**TOWN OF ERIE
PLANNING COMMISSION
July 2, 2025**

SUBJECT: **PUBLIC HEARING: Erie Highlands Filing 17 Commercial Site Plan**
A Resolution of the Planning Commission of the Town of Erie
approving the Erie Highlands Filing 17 Commercial Site Plan

Figure 3: Overall Site Plan

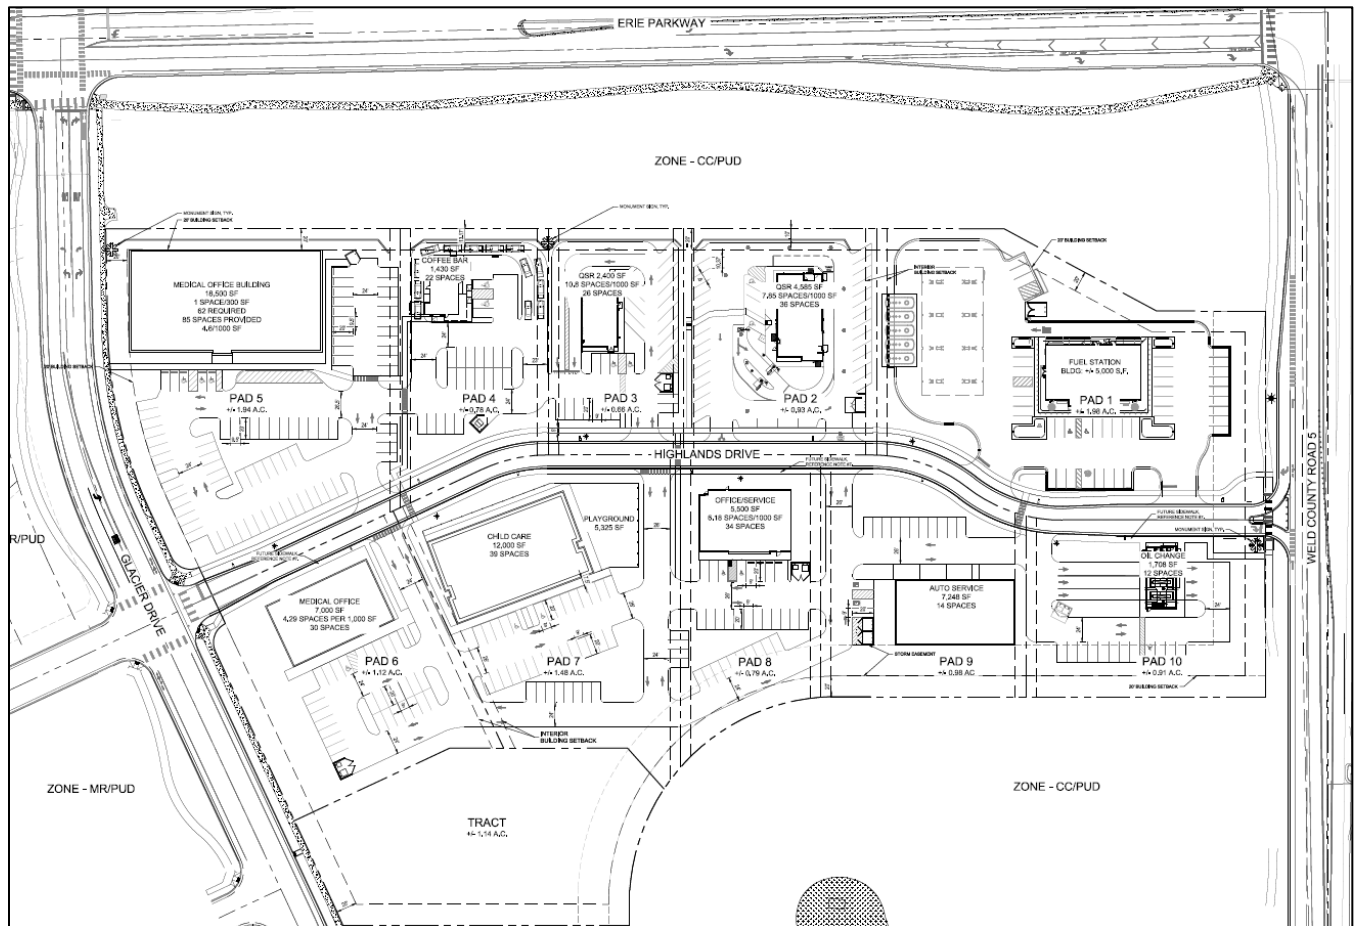
All building footprints will comply with UDC setback standards consistent with the zoning, maintaining the minimum standards:

- Front Setback: 20'
- Street Side Setback: 20'
- Interior Side Setback: 10' (0' permitted along shared walls)
- Rear Setback: 20'
- Max. Height: 45', 3 stories

Staff: The review of the Site Plan considered the design of the buildings and site in terms of its perceived impacts on neighboring properties. The location of the high traffic fuel station was selected to minimize the traffic impacts on the existing Erie Highlands residential neighborhood. No significant adverse impacts are expected.

Staff: Town staff find that this development will be compatible with the character of surrounding land uses. Building footprints and landscaping buffers are designed to minimize the impact of commercial uses on the adjacent residential neighborhood.

Figure 4: Erie Parkway and Glacier Signalization & Crossing Improvements

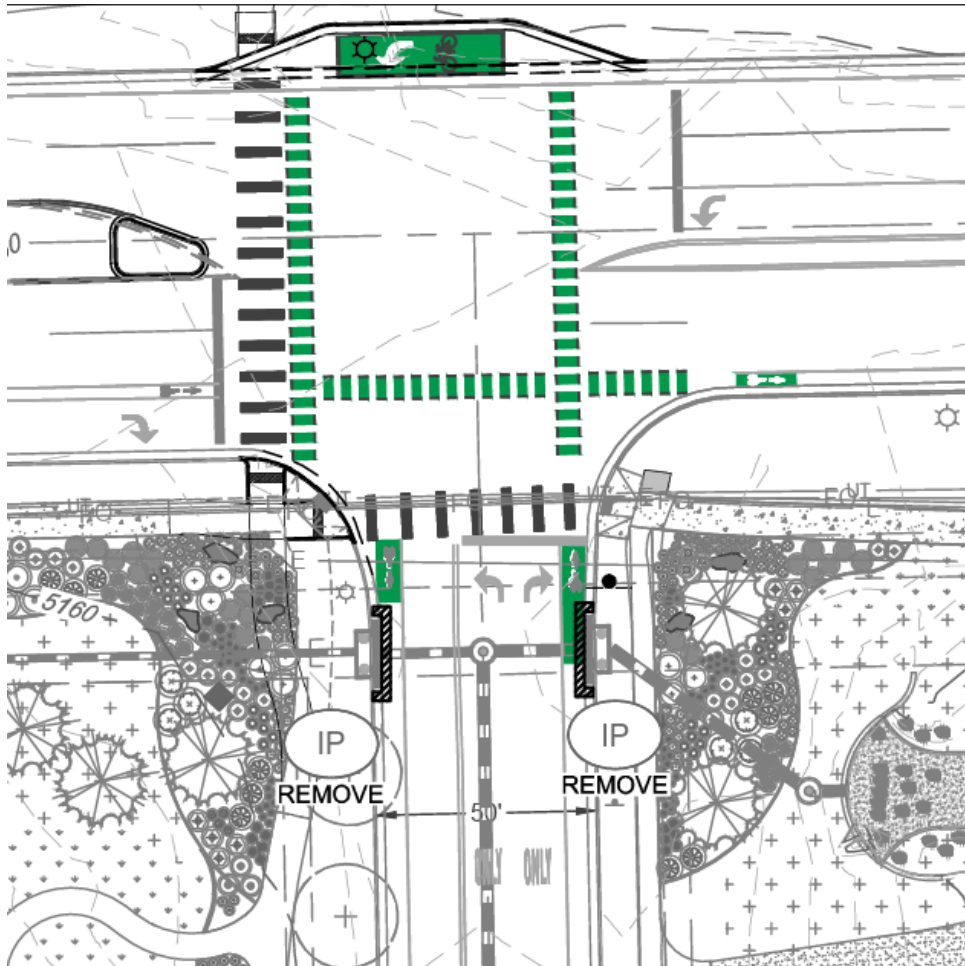
Staff evaluated projected traffic counts during the review of the Erie Highlands Filing 17 Minor Subdivision Plat. Town Council approved this application in June of 2025. The Minor Subdivision Plat application includes offsite public improvements to accommodate new traffic flows into and out of the site. These improvements include a new traffic signal at Glacier Drive and Erie Parkway, and a new deceleration lane leading to a right-in, right-out entrance from Weld County Road 5. The new entrance on Glacier Drive will be a full movement intersection with stop sign control for east-west traffic.

Figure 5: Vehicular Circulation

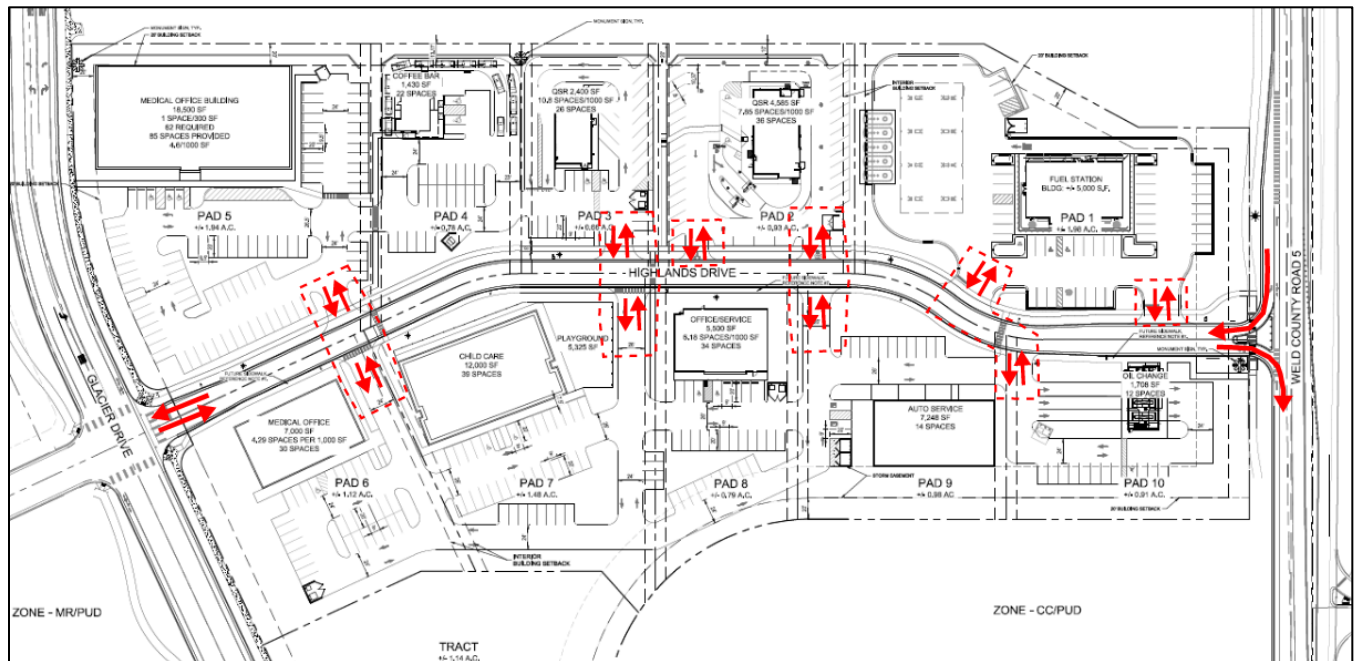
The applicant's Site Plan creates an internal hierarchy of private drives – with Highlands Drive being the primary road, and internal drives to access parking and drive-throughs. A key design component was to consolidate egress points wherever possible to minimize vehicular conflicts and enhance pedestrian safety.

Parking counts will be confirmed when subsequent site plans for individual users are submitted. Parking will conform to the standards in the UDC.

Figure 6: Pedestrian Circulation

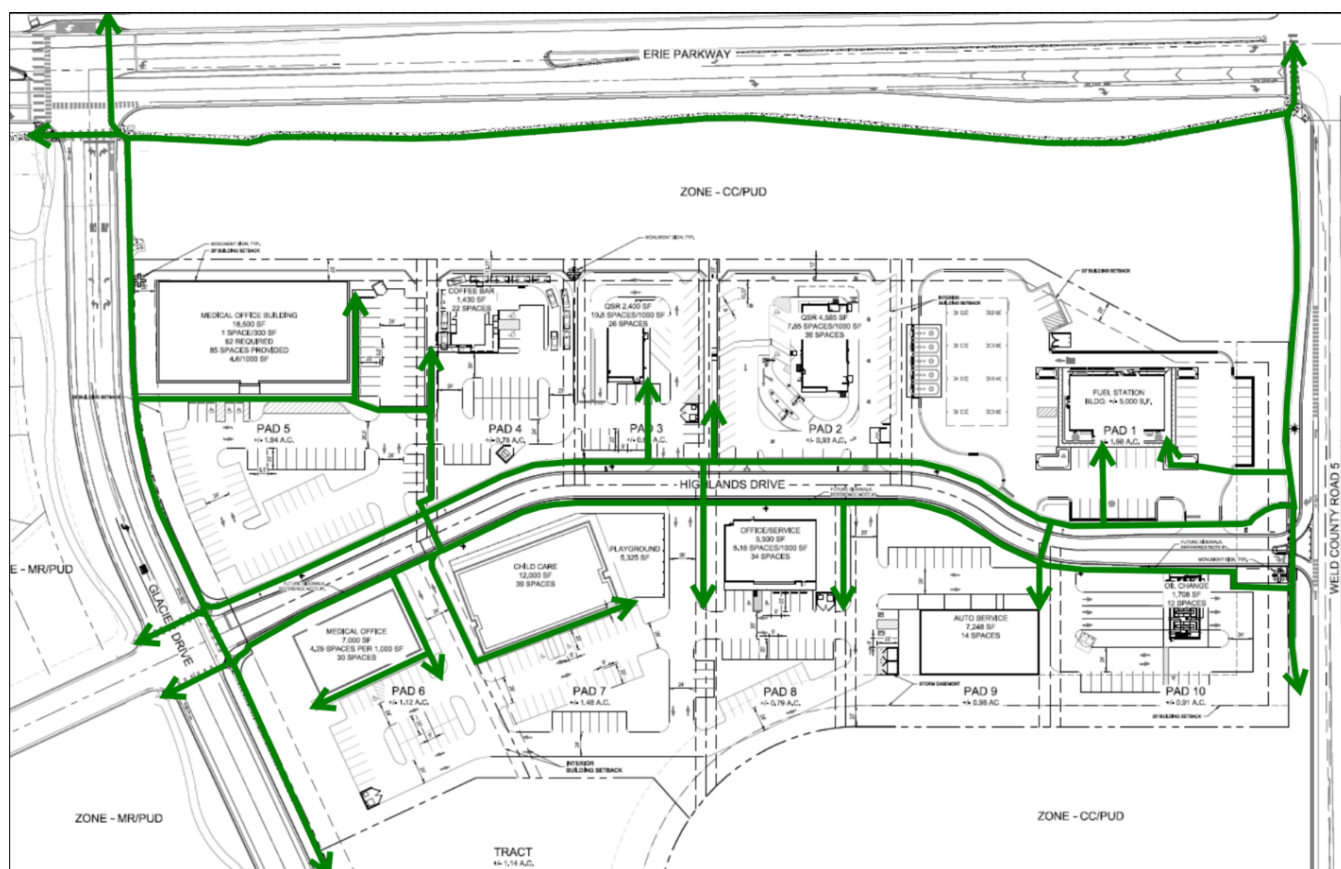
The Site Plan proposes new pedestrian connections that will tie into the existing public sidewalks on Erie Parkway, Weld County Road 5, and Glacier Drive. New crosswalks across Glacier Drive and the new alignment of Highlands Drive will help pedestrians access future businesses. Internal walkways on each lot will lead pedestrians to building entries.

The new traffic signal at Erie Parkway and Glacier Drive will also provide a new opportunity for pedestrians and cyclists to cross Erie Parkway. Bike Parking within the development will be required per UDC standards.
